## Diagnostic Trouble Code Information

1475, 1477, 1478 codes?

1. Connector 164B
3. Connector 4B

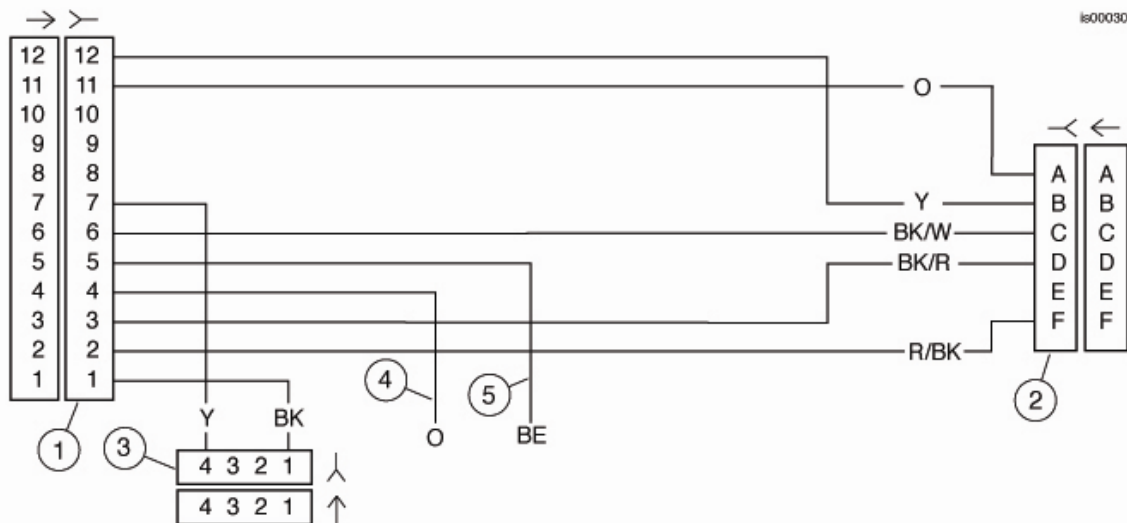
There is a correction to the wiring diagram below. It is on page 5 of the instruction sheet. The Yellow wire from connector 164B location #7 goes to pin #1 of connector 4B. The Black wire from connector 164B location #1 goes to pin #4 of connector 4B.
